Change Order Request Log

Project Name:	Newton Middle School
Project Number:	19008.00
Gen Contractor:	GH Phipps

Newton Middle School

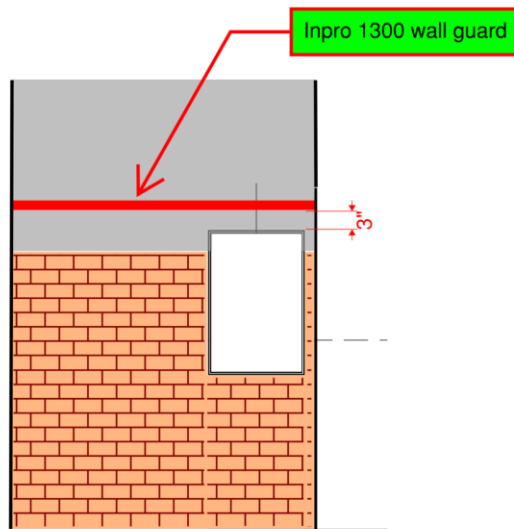
Provide Inpro 1300 wall guard horizontally on all toilet rooms walls that have the "LA" light fixture above. See the attached sketch for elevation. Color selection to follow.

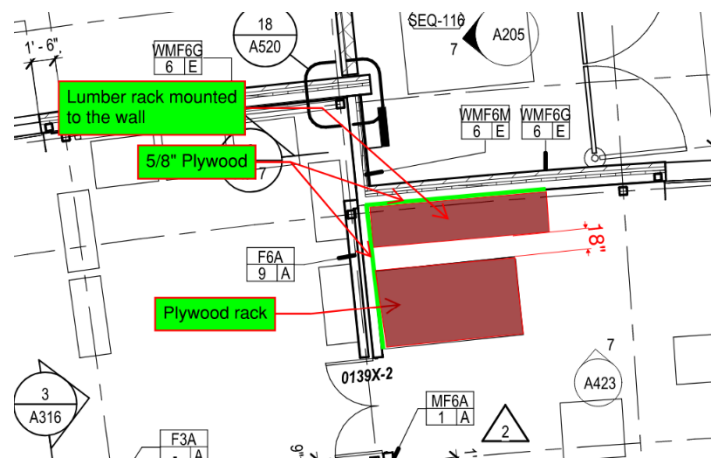
- 1) Modify the lumber rack as noted below.
 - a. Cut down the height of the rack to match the plywood rack.
 - b. Install 5/8" FR AC plywood to the walls behind the racks. Plywood full height and width of the racks.
 - c. Mount the lumber rack to the north wall.
 - d. Remove the diagonal bracing from the east side of the lumber rack only. Locate the horizontal bracing to be in-line with shelf height.
 - e. Leave 18" space between the lumber and plywood racks.
 - f. See attached picture and floor plan for additional details.
